**TRANSMITTAL OF RESPONSES TO THE UNITED STATES ENVIRONMENTAL
PROTECTION AGENCY COMMENTS AND CHANGE PAGES TO THE CONSTRUCTION
QUALITY ASSURANCE FINAL REPORT FOR PHASE III - CELL 1 FINAL COVER
CONSTRUCTION AT THE ON-SITE DISPOSAL FACILITY**

**RESPONSES TO U.S. ENVIRONMENTAL PROTECTION AGENCY
TECHNICAL REVIEW COMMENTS ON THE
CONSTRUCTION QUALITY ASSURANCE FINAL REPORT,
PHASE III-CELL 1 FINAL COVER CONSTRUCTION
ON-SITE DISPOSAL FACILITY
(20103-CA-0001, REVISION 0)**

FIGURE NO.	2-1
PROJECT NO.	GQ1341-03.1
DOCUMENT NO.	F0131105.CDG
FILE NO.	F02F001.DWG

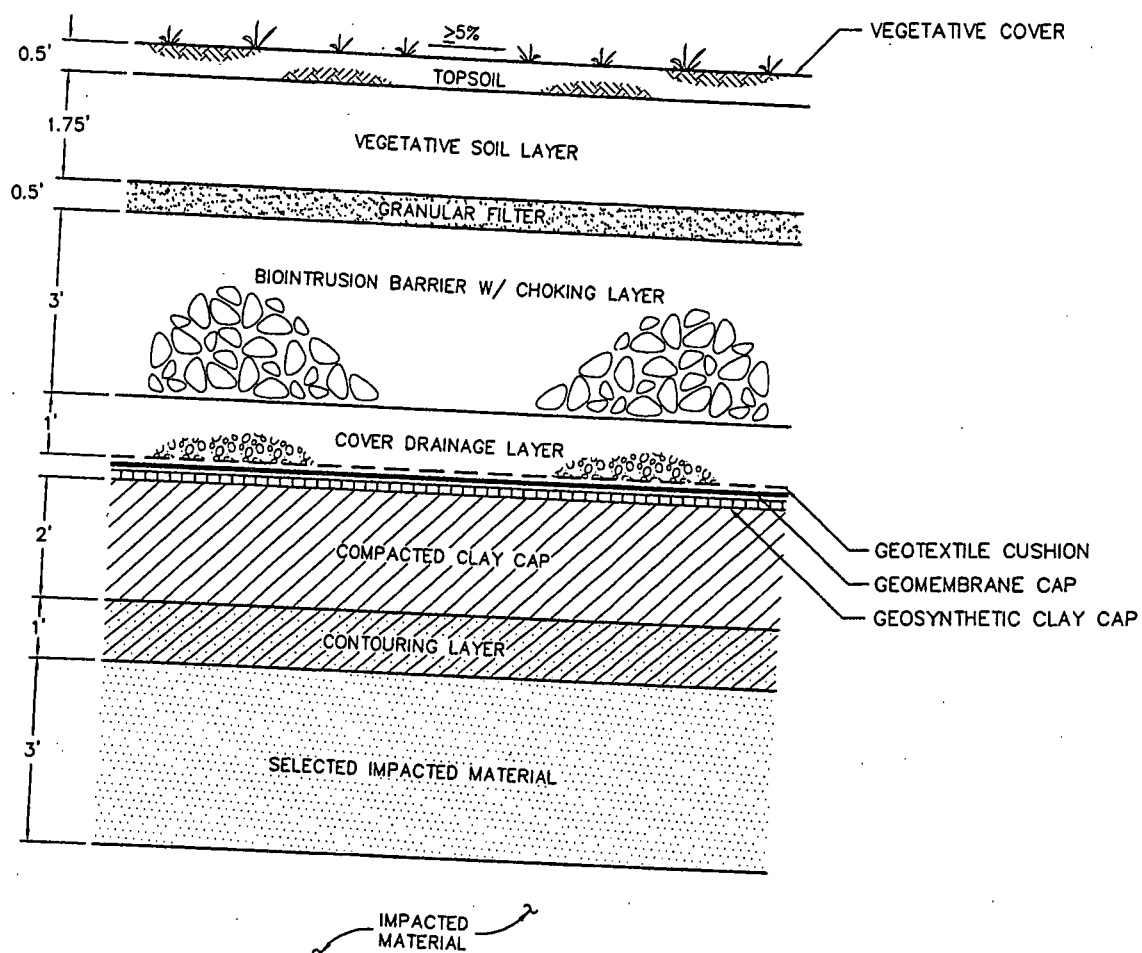
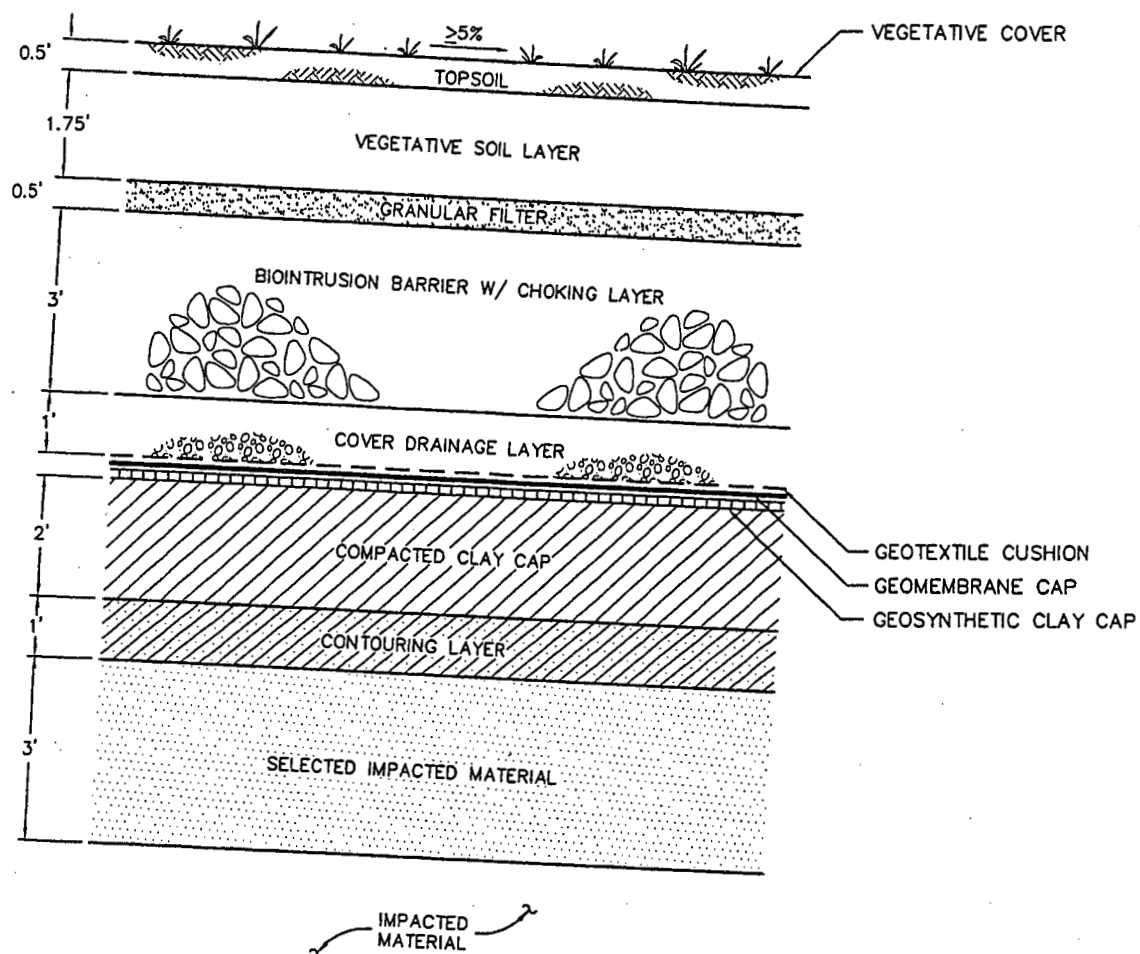
Comment: Although detailed drawings of the cover system are included in other portions of the report, a cross section of the cover should be provided in Section 2 to support the discussion of the various layers.

Response: GeoSyntec Consultants agrees with U.S. EPA that a cross section of the final cover system would help illustrate the components of the various layers constructed.

Action: Figure 2-1 (Cross Section of Final Cover System) has been added at the end of Section 2. Also, Section 2 of the narrative has been revised to reflect the addition of Figure 2-1.
